Process / Product Change Notification

N° 1211-DISTI42-C4048408-Private

Introduction of an Additional Wafer Production Location GTBF Dongguan, China for TO220 and D2PAK 3L MOSFET Products.

Factory code marking

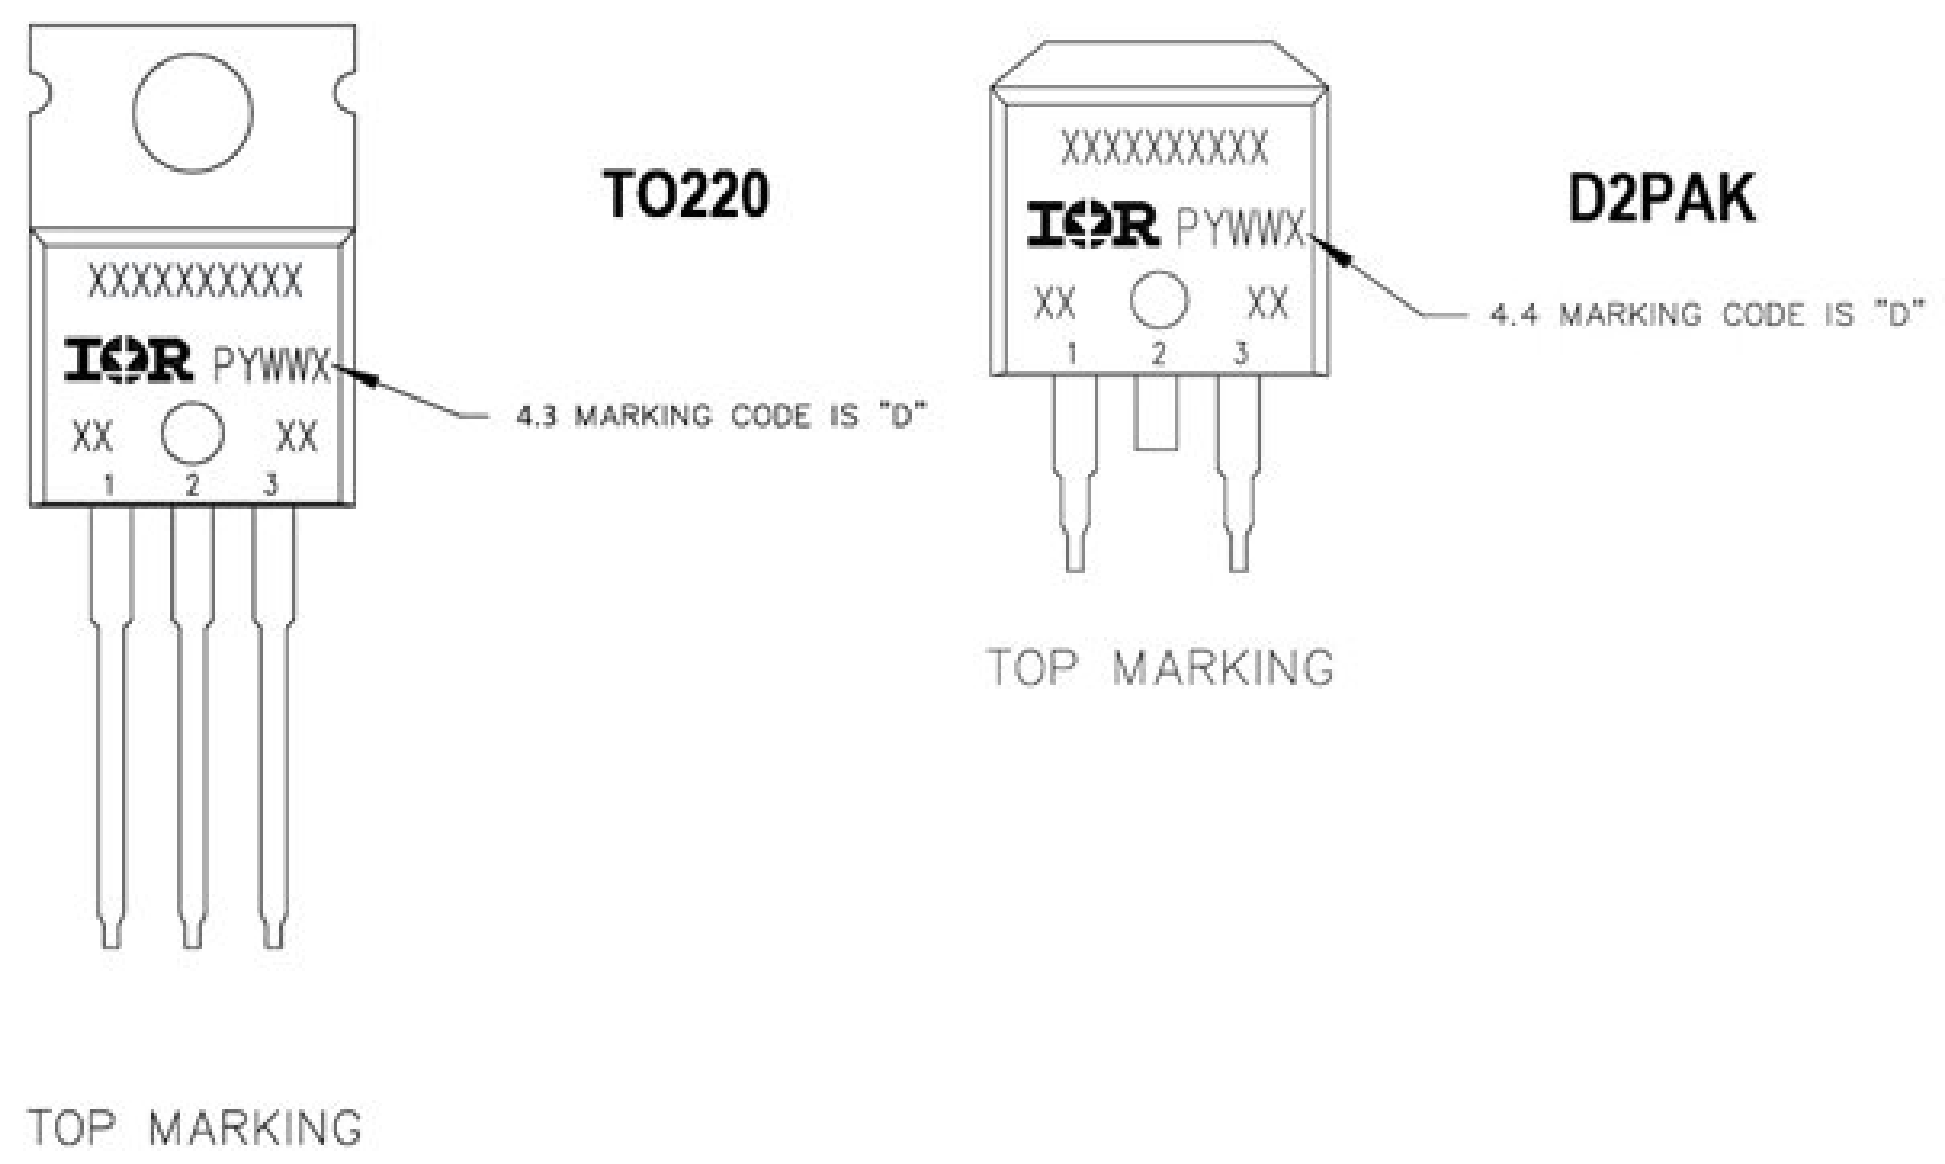
Old	New
TO220	
- **Assembly site** SP Semiconductors, Korea	SP Semiconductors, Korea and GTBF Dongguan, China
- **Wire type** Aluminum	NI-Doped Aluminum
- **Mold compound** SG-8200DL	KE-G300BH
D2PAK	
- **Assembly site** SP Semiconductors, Korea	SP Semiconductors, Korea and GTBF Dongguan, China
- **Wire type** Aluminum	NI-DOPED AL WIRE
- **Mold compound** SG-8300HDT	CEL9220HF13MGP

Product Identification:	Traceability assured via date code. Factory code marking is "D“(Section 4.3 for TO220 and Section 4.4 for D2Pak) at GTBF.
Impact of Change:	No impact on electrical performance. Quality and reliability verified by qualification. There is no change in form, fit and function.
Attachments:	1211-DISTI42-C4048408-AffectedParts.xlsx
